REQUEST FOR EXCEPTION TO RAPID CITY DESIGN STANDARD / CRITERIA / REGULATIONS

PROJECT Lots 1 Through 3, Market Square Subdivision	
DATE: 5/26/17 SUBMITTED BY: (Include Name, Company Name, Email Address & Phone Number)	Sperlich Consulting, Inc.
PIN #:	info@sperlichconsulting.com, (605)721-4040
LEGAL DESCRIPTION: A Portion of Lot B of Lot 3 of Tract D, Section 5, T1N, R8E, B.H.M., Rapid City,	
Pennington County, South Dakota	
EXCEPTION REQUESTED: SECTION 3.5.	
Do not construct 36' wide pavement, curb, gutter, sidewall	public dual water mains and the balance of the 12" main within Creek Drive.
25 Not sometime to wide pavernerit, early, gutter, sidewaii	Grak Drive
JUSTIFICATION:	
(Please use back of sheet if additional room is needed) Proposed	Lots 2 and 3 will have existing access off of East St. Patrick Street.
	ccess along Creek Drive is limited based on arterial street criteria. Patrick, Proposed Lot 3 will service water off of existing main
	off of existing water main within East St. Charles Street.

Re: Exception 17EX117

Request to waive the requirements to install a dual water main, 12" water main in the balance of the road, additional pavement width, curb, gutter, sidewalk, ha

<u>-RapidMap</u>

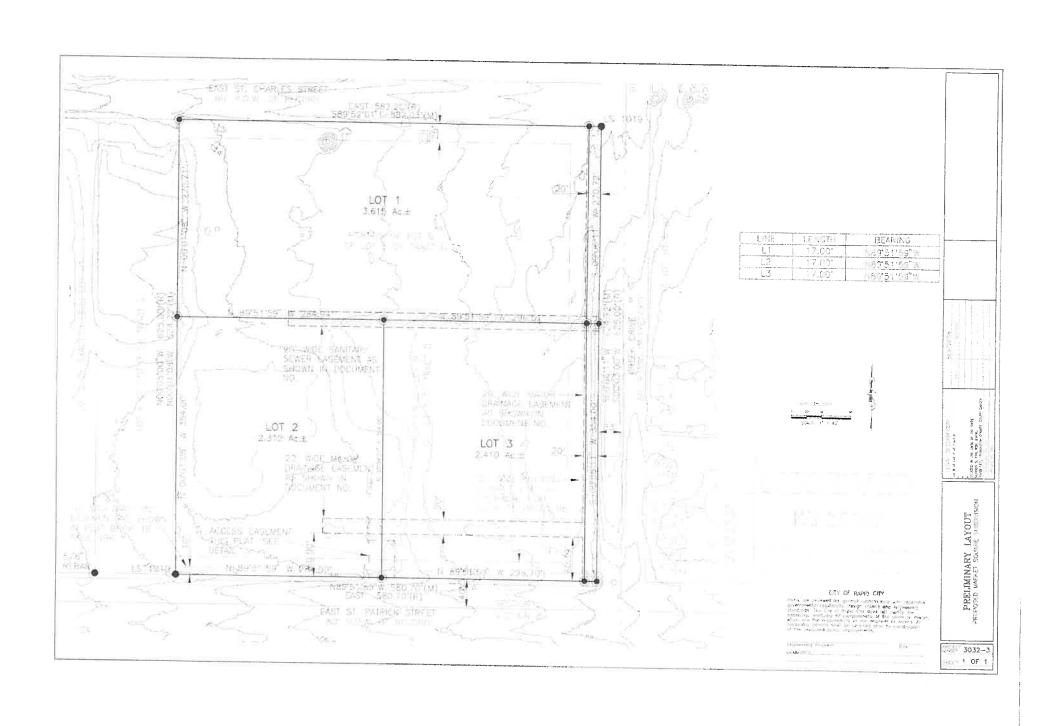
Approximately 300' of adjacent Creek Drive is void of water main. An extension of the 12" water in Creek Drive from its current terminus to connect to the water main in East St. Patrick Street is required to eliminate a long dead end water main which is approximately 1700' long today. Of which the current Infrastructure Design Criteria Manual Section 3.9.10 limits dead end mains to 1200'. Water main looping will provide redundancy within the water system and additional domestic and fire flows for the proposed development.

The request to waive the requirements to install a dual water main in Creek Drive is approved.

The requests to waive the requirements to install 12" water main in the balance of the right-of-way, additional pavement width, curb, gutter, sidewalk, handicap ramps and street light conduit in Creek Drive are <u>denied</u>.
